Plan Commission

[2019-0756](#) LaGrange Square - Development Petition for a Special Use Permit Amendment with Modifications, Site Plan, Elevations, Landscape Plan, and Subdivision

File Number: **2019-0756**
Orig. Department: **Development Services Department**
File Name: **LaGrange Square - Development Petition for a Special Use Permit Amendment with Modifications, Site Plan, Elevations, Landscape Plan, and Subdivision**

SHEET NO. **C201**

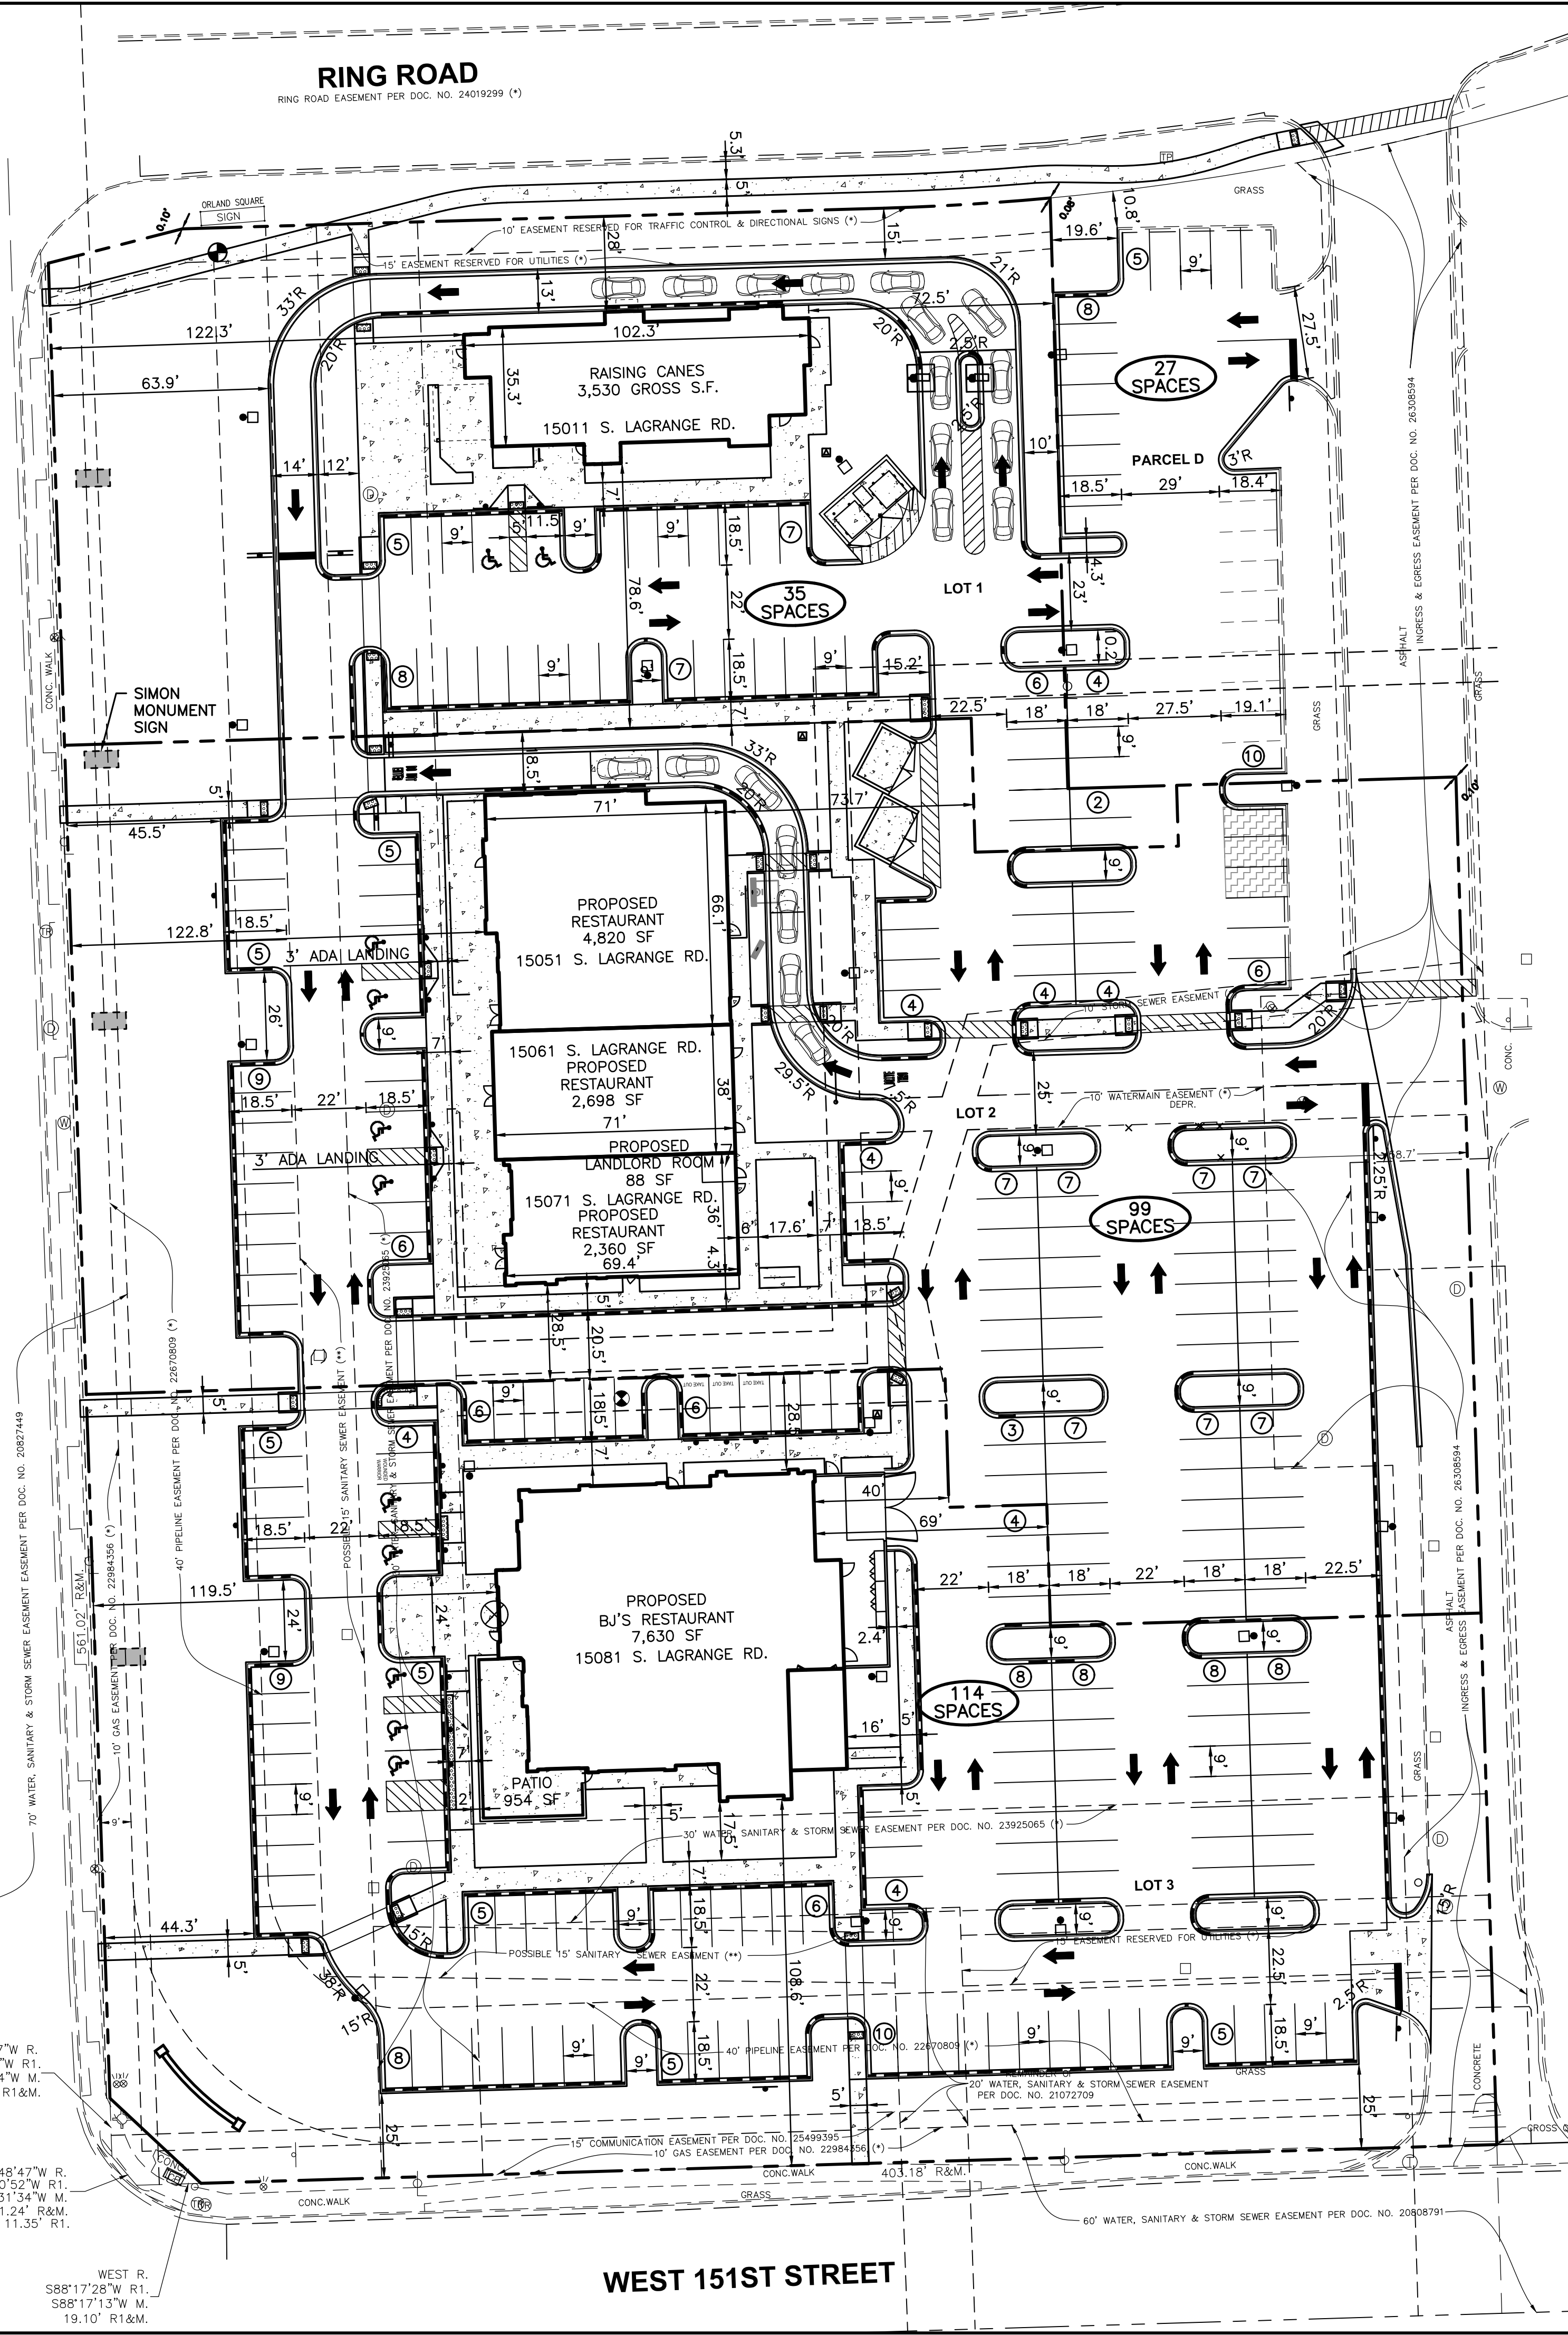
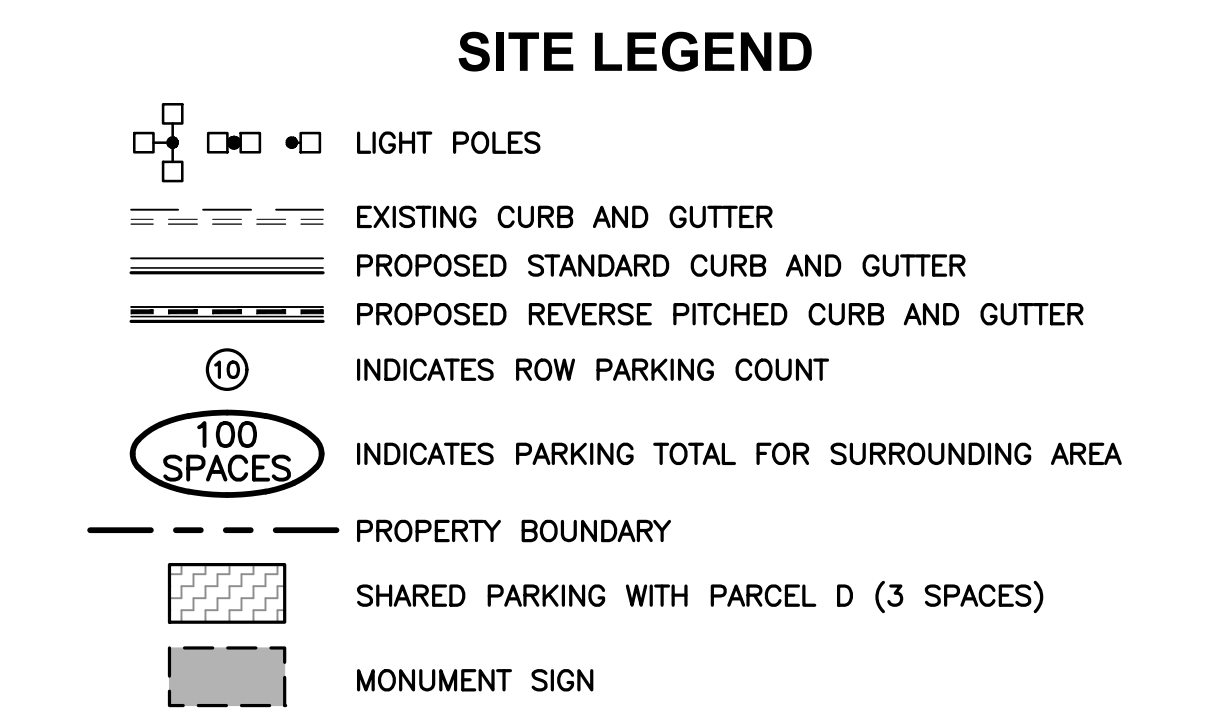
I move to recommend to the Village Board of Trustees approval of the **Preliminary Site Plan** titled "Site Plan" (Sheet C200) and "Site Data Plan" (Sheet C201), prepared by Woolpert, Inc., dated October 10, 2019, and last revised February 25, 2020, subject to the following conditions:

1. Meet all building code requirements and final engineering requirements, including required permits from outside agencies.
 2. Screen all mechanical equipment either at grade or at rooftop with landscaping or parapets respectively.
 3. Submit a sign permit application to the Development Services Department for separate review. Signs are subject to additional review and approval via the sign permitting process and additional restrictions may apply.
 4. The photometric plan shall comply with all lighting requirements per Section 6-315.
 5. Provide additional plant material between the proposed drive-through lane on Lot 1 and the adjacent streets (LaGrange Road and the Ring Road) to screen the drive-through lane from the
-

PRELIMINARY SITE PLAN FOR MEGAN NICOLE RIDGE SUBDIVISION

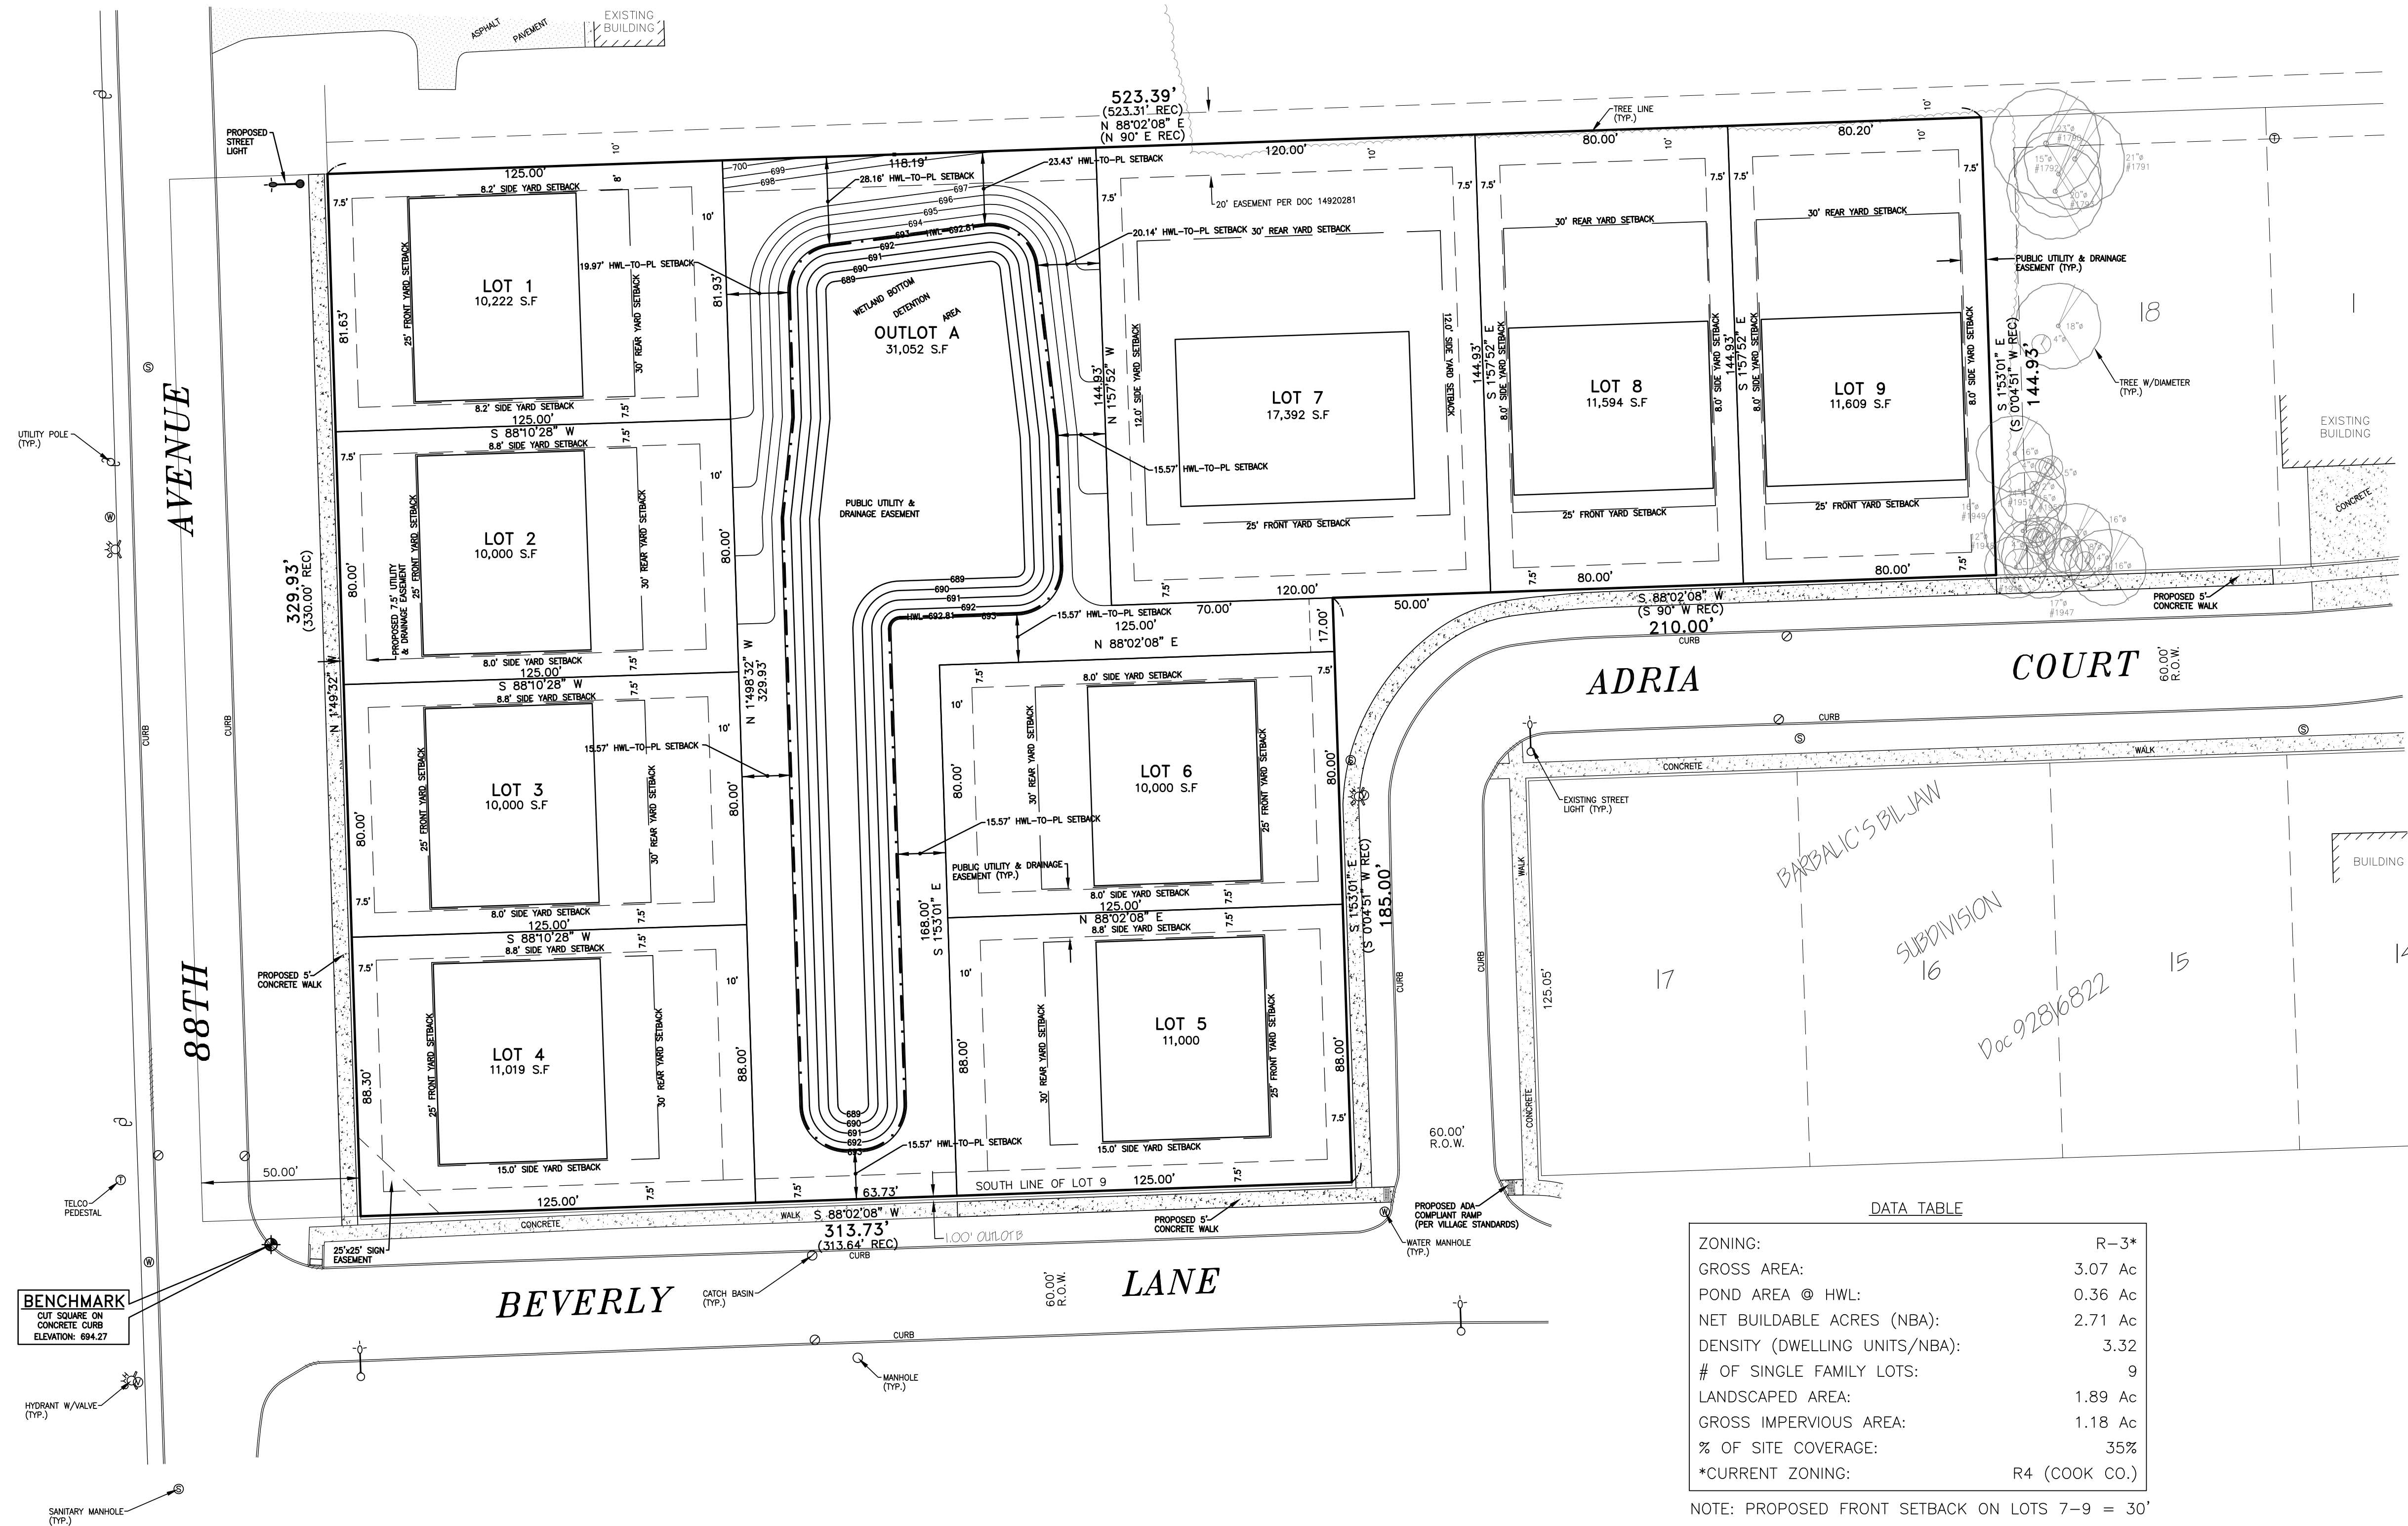
I move to recommend to the Village Board approval (upon annexation) of the **Preliminary Site Plan** titled “Preliminary Site Plan for Megan Nicole Ridge Subdivision”, prepared by Landmark Engineering, LLC, Sheet PSP1, dated July 8, 2019 and last revised January 15, 2020, subject to the following conditions:
